AP1000 DOCUMENT NO.	REVISION	PAGE	ASSIGNED TO	OPEN ITEMS (Y/N)
APP-GW-GLR-134	1	1 of 470	W-Sterdis

TITLE: **AP1000 DCD Impacts to Support COLA Standardization**

AP1000 Standard Combined License Technical Report

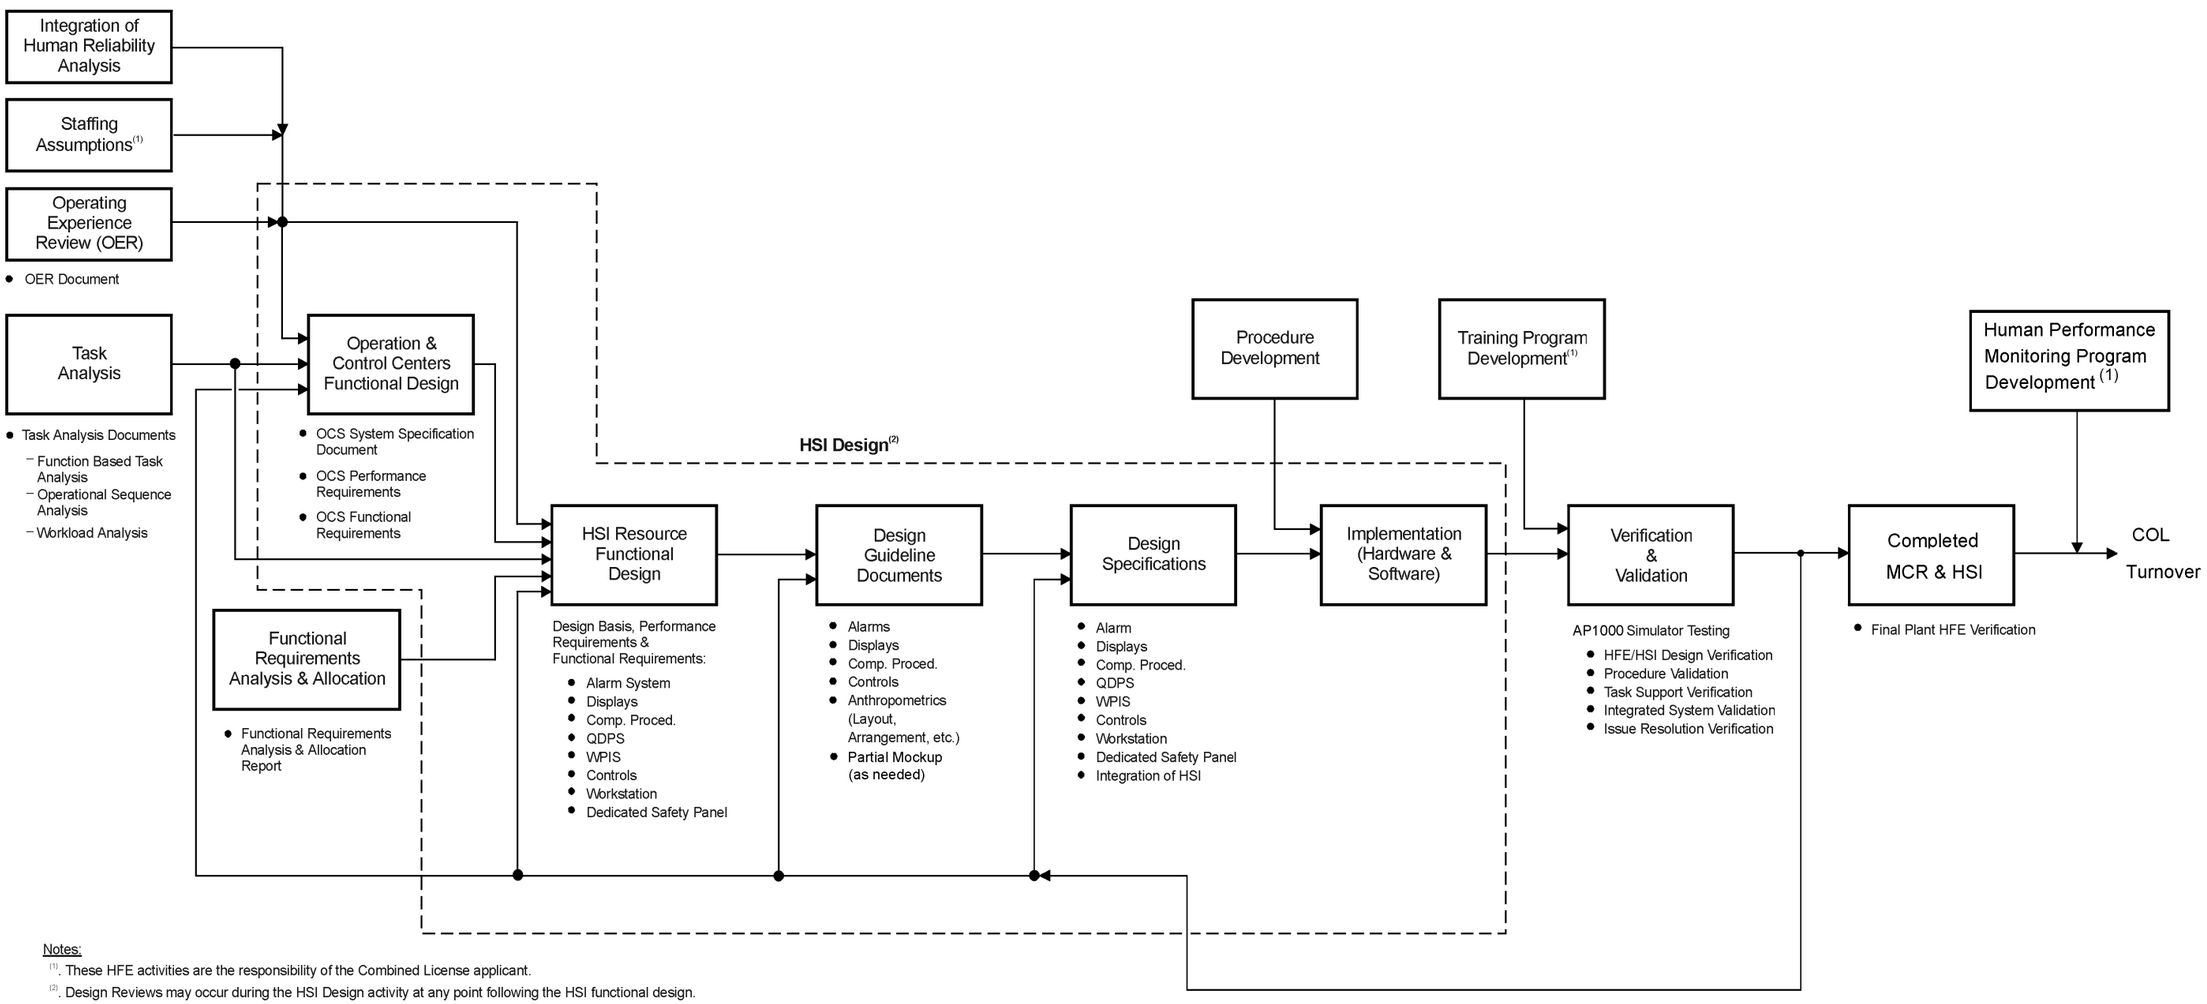
NRC065 contains an editorial correction to delete the parenthetical reference to Note 1, (1), in the box containing the words "Procedure Development" on DCD Figure 18.2-3

The basis for this deletion is Revision 1 of Technical Report 70, APP-GW-GLR-040, which closes COL Applicant actions with respect to Operating Procedure development. In addition, this deletion will ensure that Figure 18.2-3 of the DCD is consistent with Table 1.8-2 which clearly states that, with respect to COL Information Item 18.9-1, there are no COL Applicant or COL Holder actions required.
